SUBJECT: Addendum 2
A New Baseball Field for Worth County High School
Worth County School District

**A NEW BASEBALL FIELD
FOR WORTH COUNTY HIGH SCHOOL
WORTH COUNTY SCHOOL DISTRICT
ADDENDUM NO. 2
May 10, 2022**

1 ELECTRICAL SITE PLAN - OVERALL
E1001 SCALE: 1" = 30'-0"

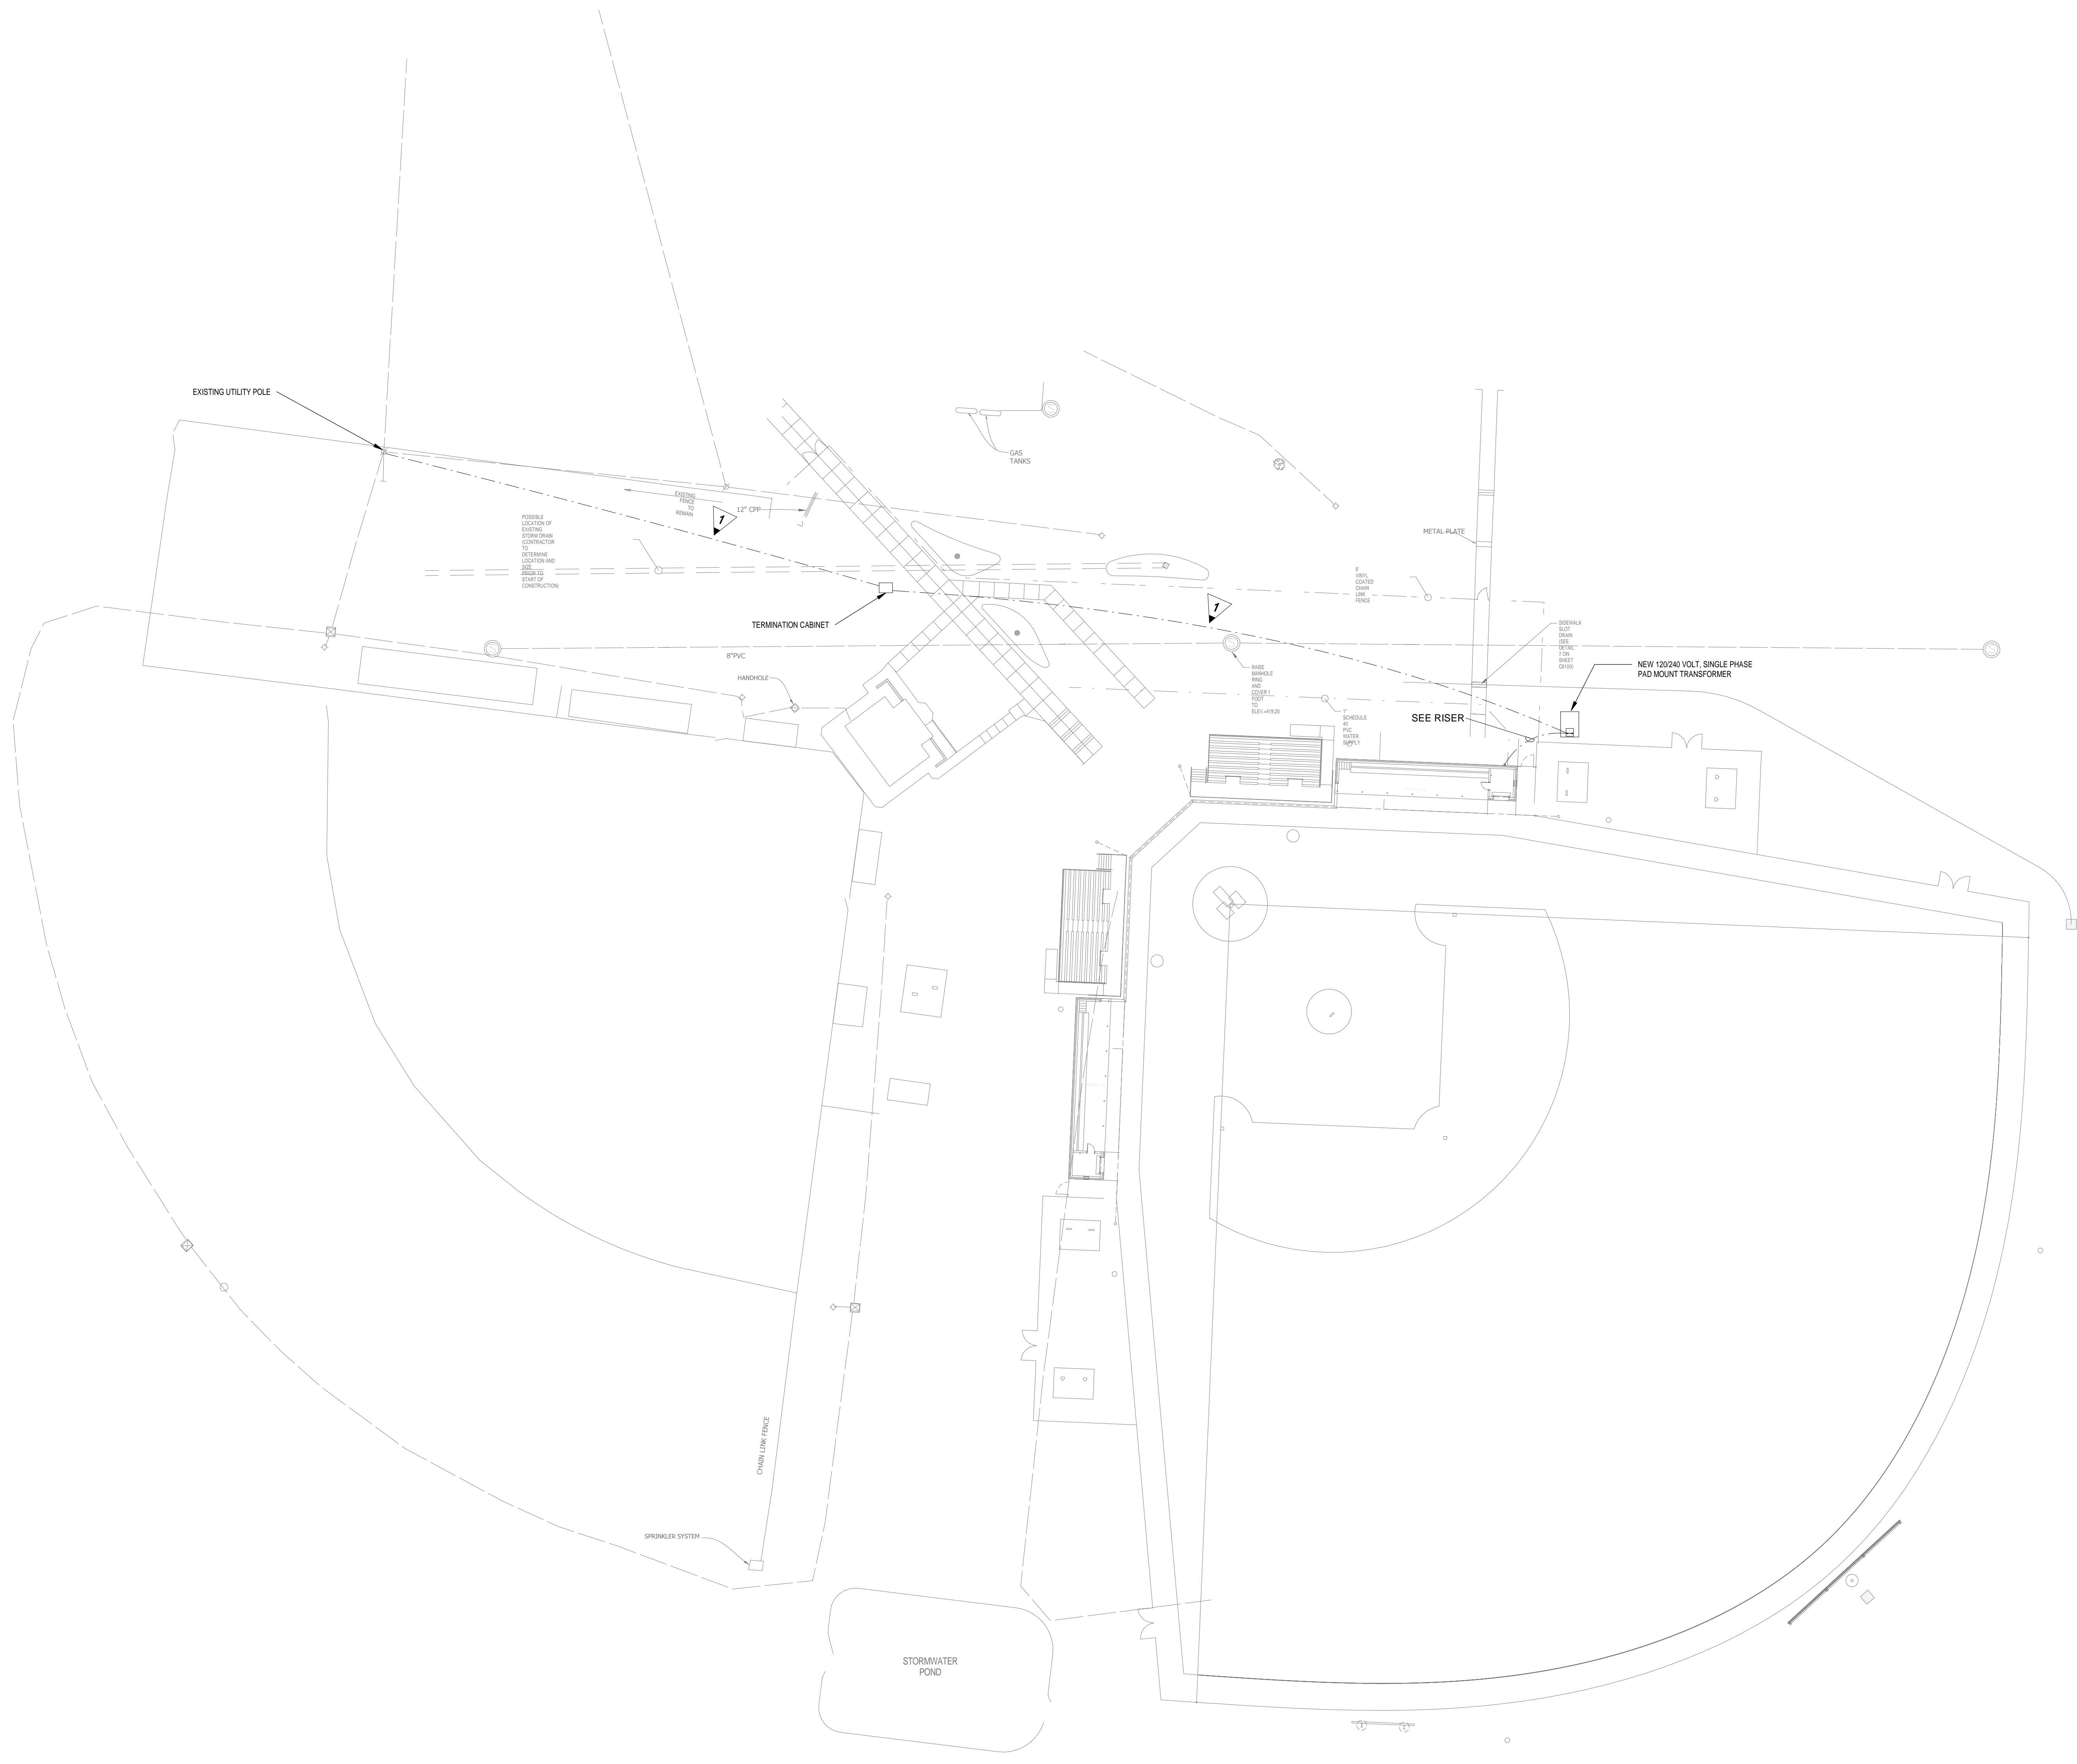
6. Sheet A2000:
 - a. Field Plan Baseball:
 - i. Add the following note at each location where drawing indicates (2) 6' WIDE GATES; COORDINATE EXACT GATE LOCATION WITH ARCHITECT AND OWNER PRIOR TO INSTALLATION.
7. Sheet E1001:
 - a. Add the attached Sheet E1001 in its entirety which adds the required work for electrical service.
8. Sheet E1002:
 - a. Delete Sheet E1002 in its entirety and replace with the attached Sheet E1002 which shows clouded changes for the electrical service and adds requirements for the sound system.
